**Appendix 1 to document ECE/TRANS/WP.15/AC.2/2011/38
on the use of liquefied natural gas as a fuel**

**RECOMMENDATIONS TO INSPECTION BODIES
RELATING TO THE ADN REGULATIONS**

Liquefied Natural Gas to be used as fuel for the vessels' propulsion

HAZARD IDENTIFICATION STUDY

CHEMICAL TANKER - "ARGONON"
LNG PIPELINE DIAGRAM

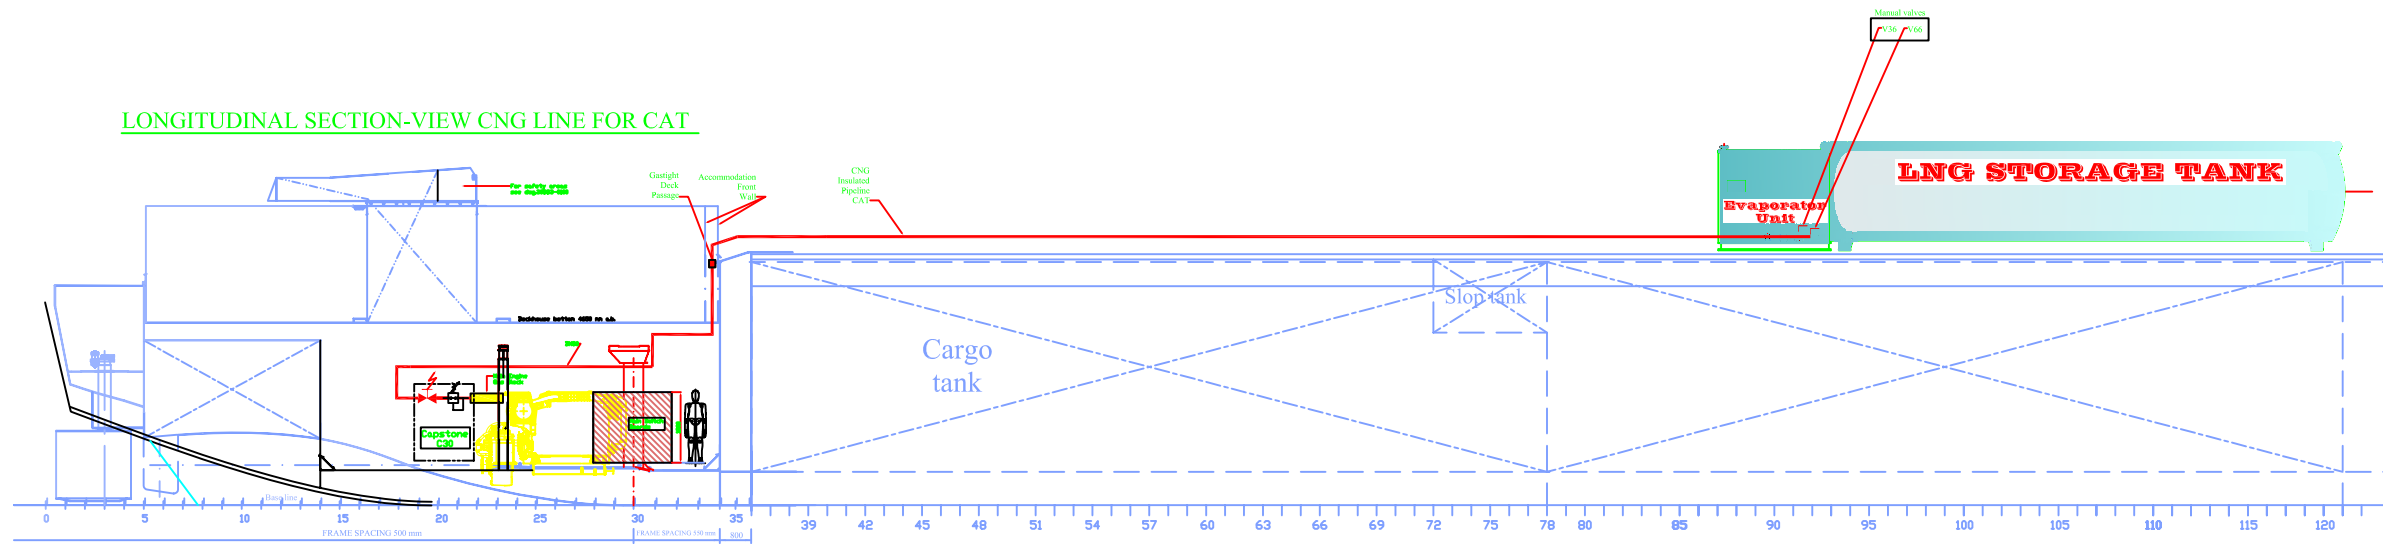
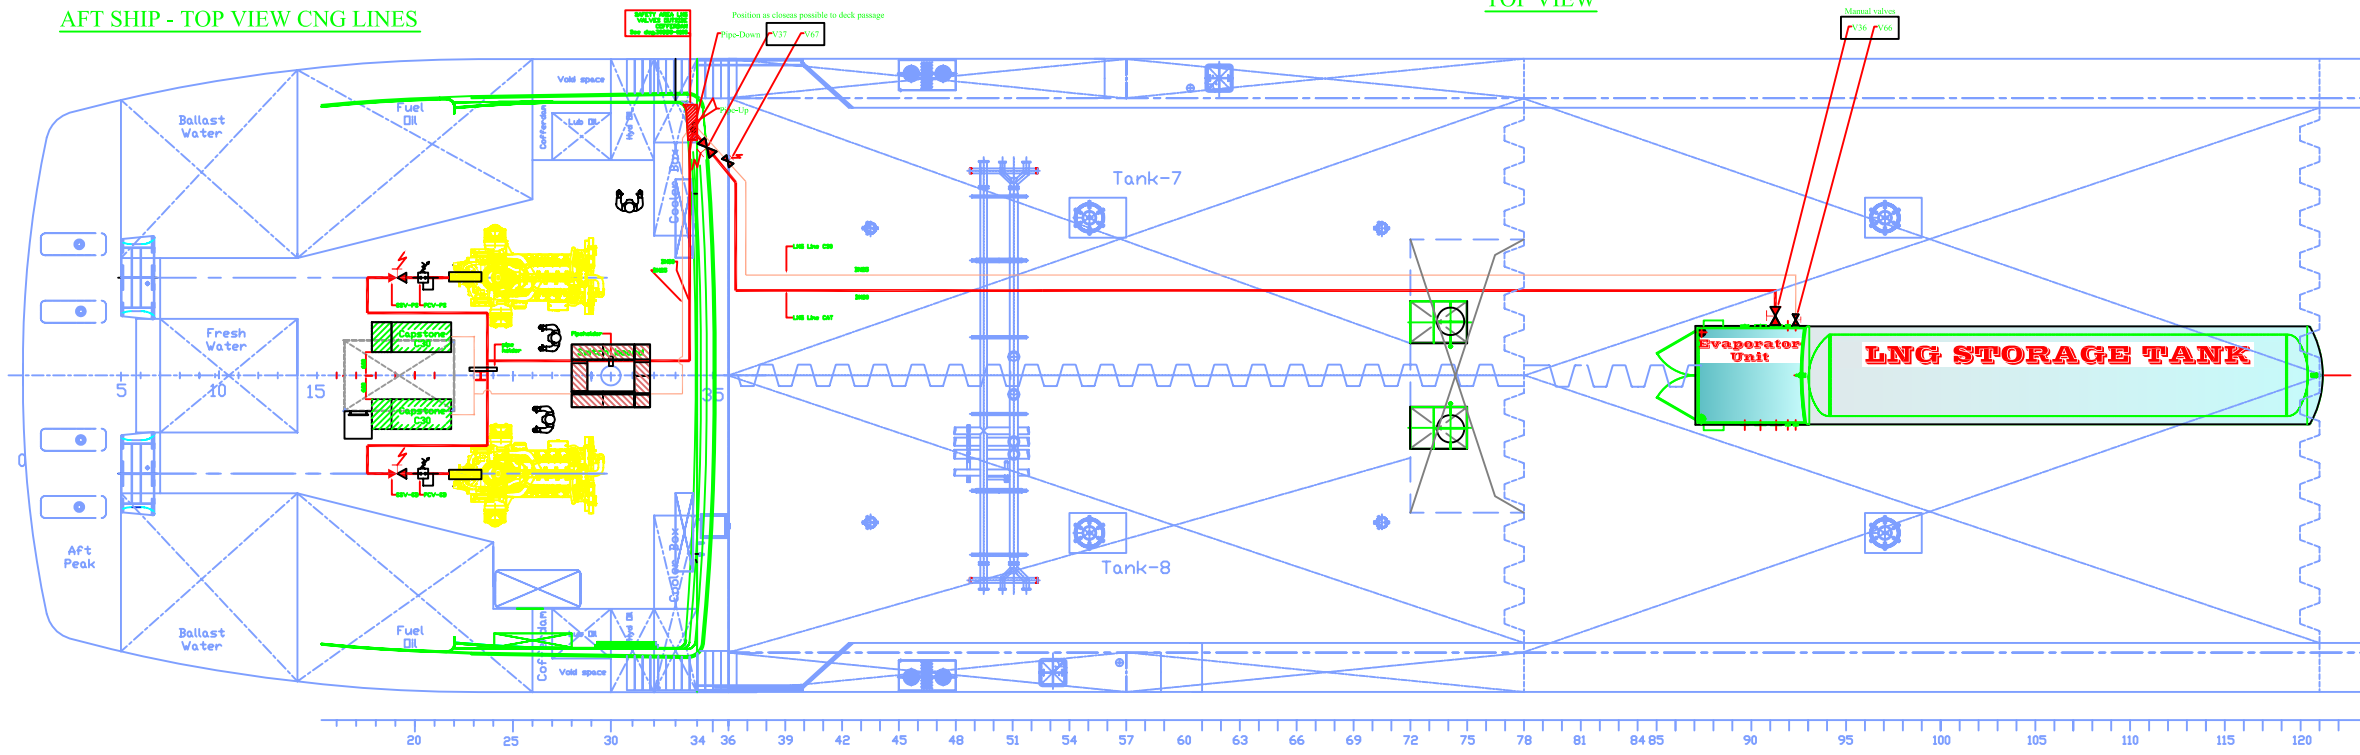
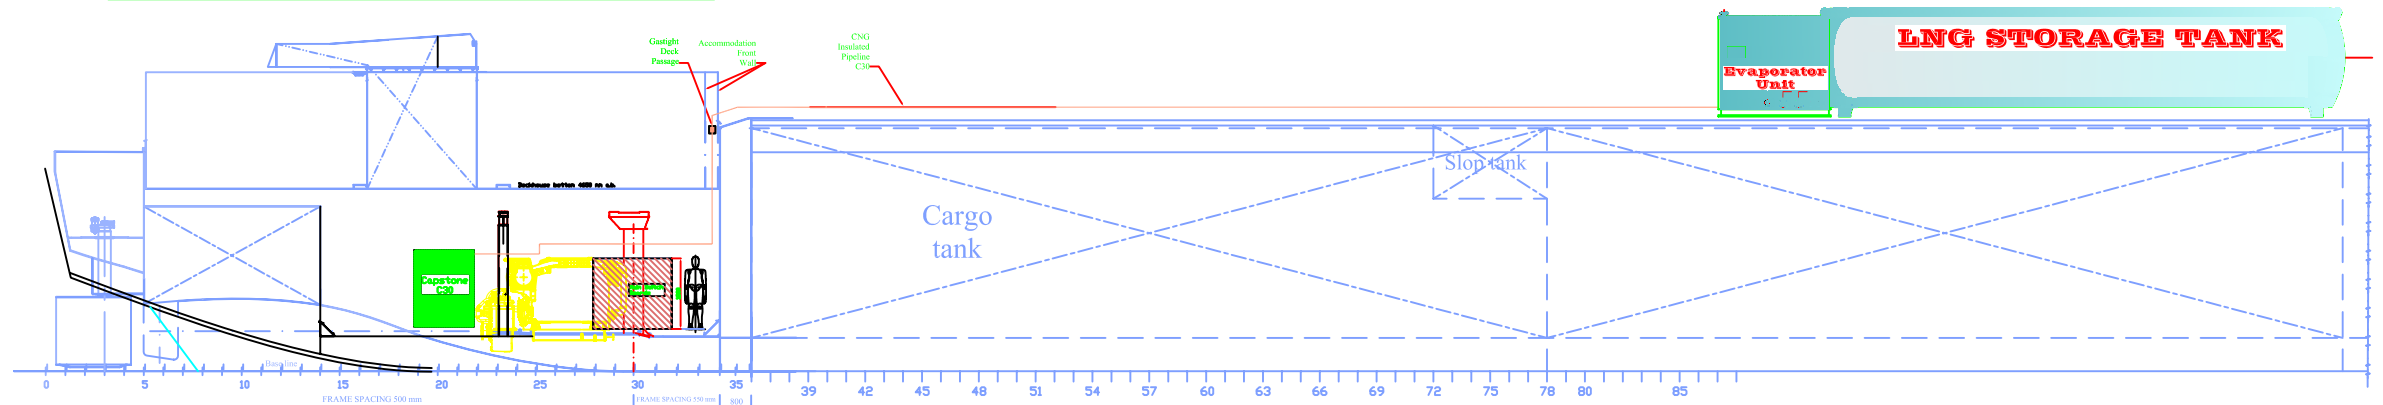
System: LNG machinery room arrangement - ventilation and gas detection		Drawing: 400-00_LNG Pipeline Diagram			HAZID sheet 6
Area: Machinery space		Revision: A			29 November 2010
Equipment : Machinery					
ITEM	CAUSE	HAZARD	POTENTIAL EFFECTS	SAFEGUARDS	RECOMMENDATIONS
Machinery arrangement					
Continuous operation underway					
6.1. Rupture					
6.1.1	Double walled pipe section	Failure of inner pipe	Gas release	Gas inlet pipes are double walled up to the engine. Nitrogen inside double walled pipe with pressure alarm.	IWW application to be further considered with regards to automatic shut-down of gas valve and purging with nitrogen.
6.1.2	Single walled pipe at engine			Proper support and robust design so complete rupture is not being considered. System rated 16 bar with working pressure 2 bar. Partial failure of pipe through cracks, seals e.t.c. is considered below under 11.2

1002-110
 SHEET : 1/3
 COPYRIGHT CRYONORMPROJECTS BV
 www.cryonormprojects.com

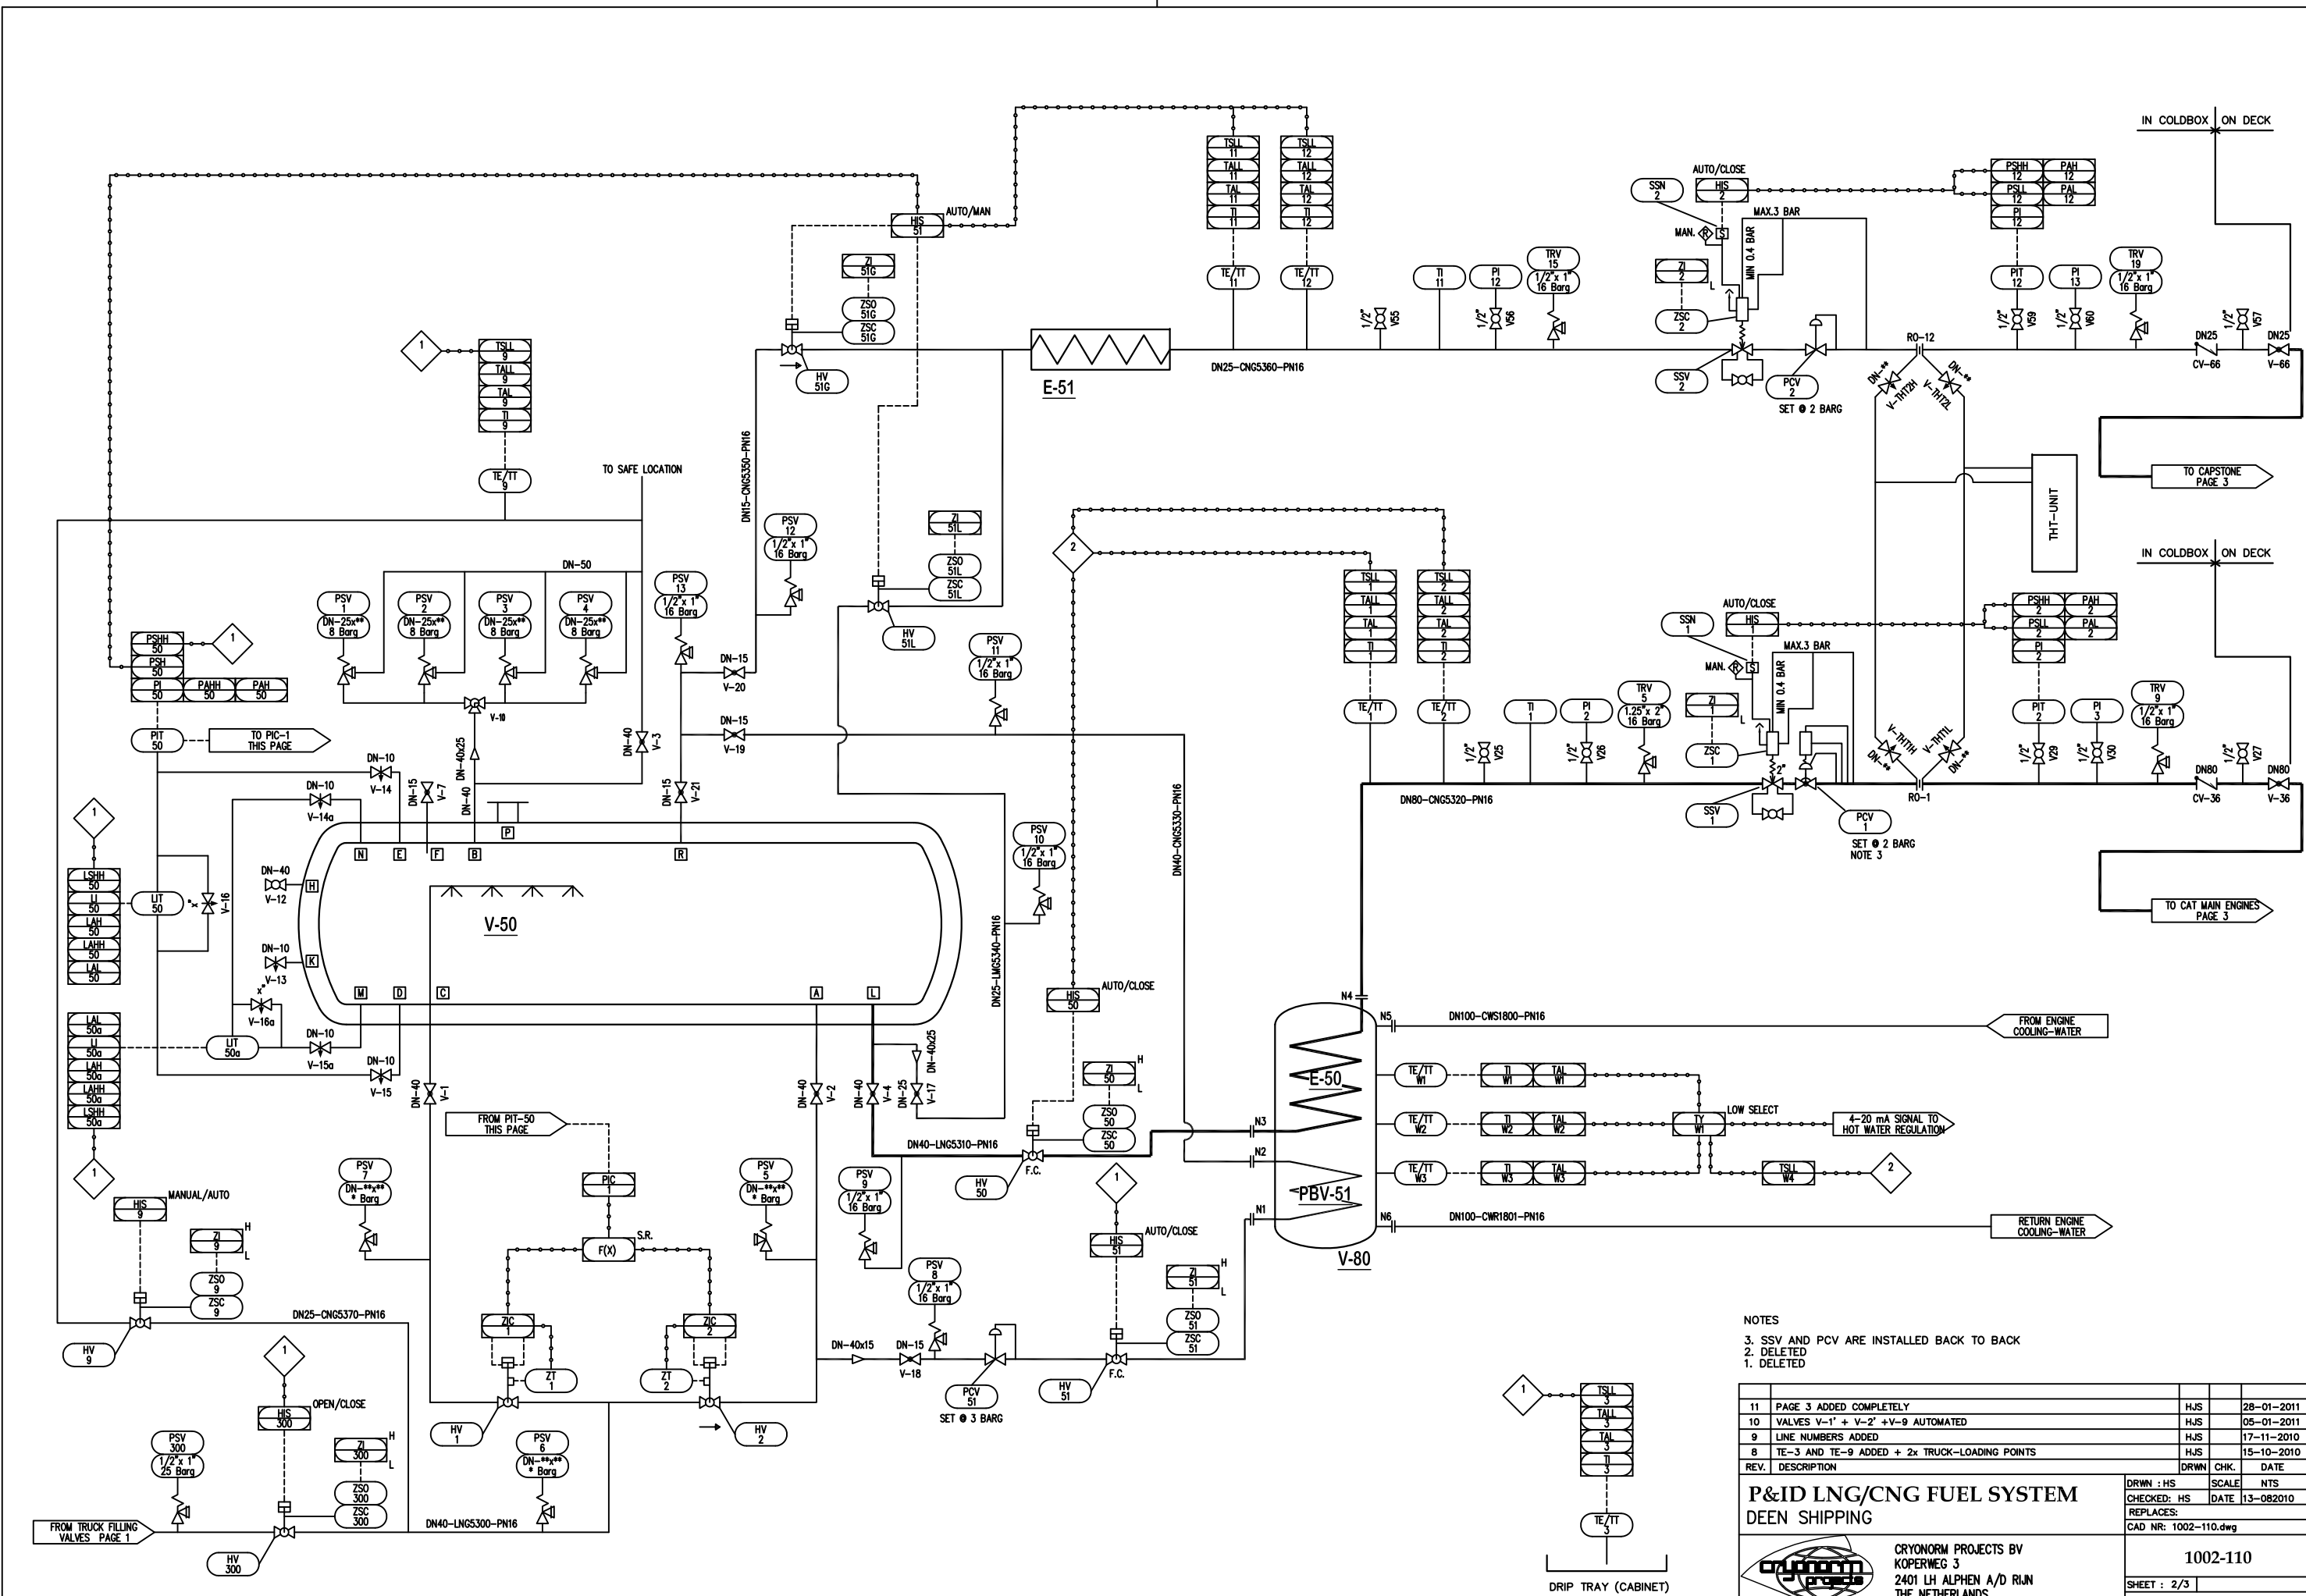
System: LNG Tank design and location		Drawing: P&ID LNG Fuel System (CRYONORM)			HAZID sheet 1
Area: Cargo area		Revision: 1002-110 Rev 7			11 and 12 October 2010
Equipment : LNG supply

ITEM	CAUSE	HAZARD	POTENTIAL EFFECTS	SAFEGUARDS	RECOMMENDATIONS
2.4 Impact	Collision	Gas release	Fire	Manifold inboard minimum 2m, AND(R)	
2.5 Fire / Explosion	External cause	Fire		Stop bunkering, emergency manual shut down bunkering ESD valves	See also sheet 1. comments
